RE: PCN Production Transfer for Acquired ON Semiconductor Automotive TVS Diodes SMB (DO-214AA) and SMF (SOD123)

Device Marking Change: following production transfer into our Wuxi, China site.

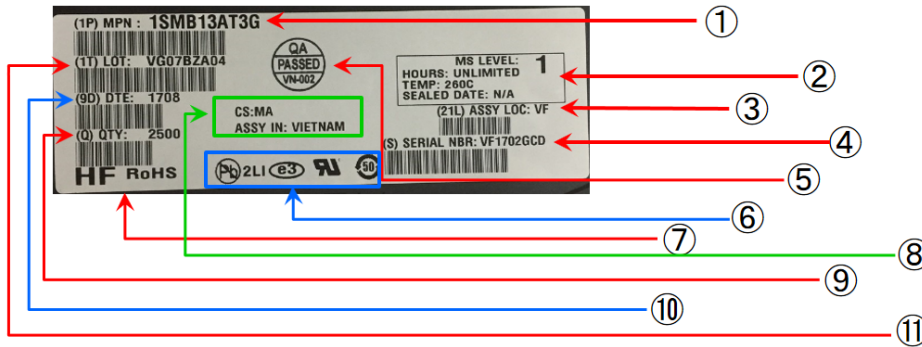
Package	SMA	SMB	SMC	SMF (SOD123 - FL)
Existing (ON)				
Modified (LF)	 XXXX = Device Code Y = Year M = Month A = Assembly Location WW = Lot Code			 XX = Device Code Y = Year M = Month A = Assembly Location WW = Lot Code
Modification Items	1. Intergrat SMA, SMB and SMC using same marking diagram. 2. Use five digits trace code for better traceability. 3. Remove Pb-free dot. 4. Change polarity band quantity from three to one.			1. Change marking from one line to two lines. 2. Use five digits trace code for better traceability. 3. Remove Pb-free dot. 4. Change polarity band quantity from three to one.

Note: Polarity band is only for uni-directional components.

New label format: following production transfer into our Wuxi, China site.

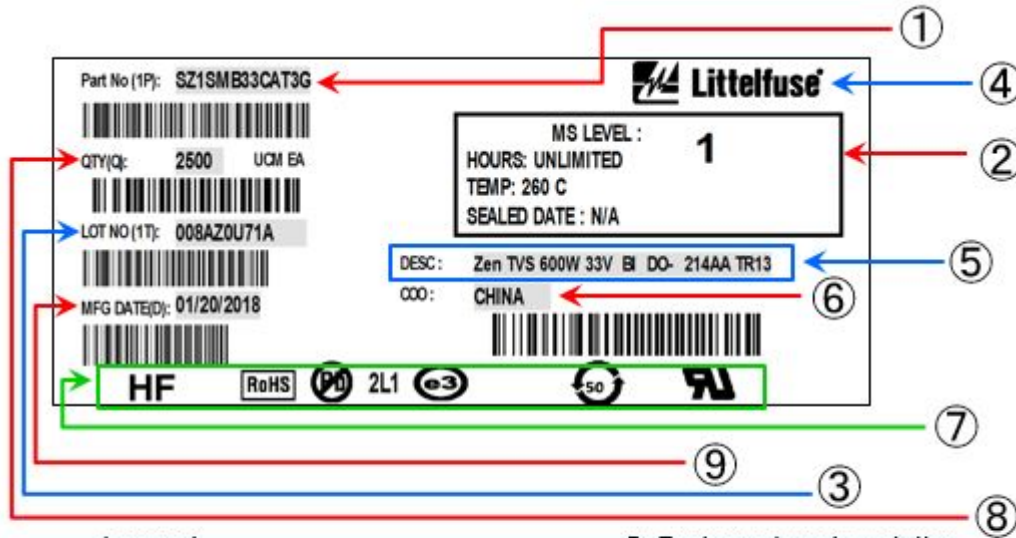
Current label format:
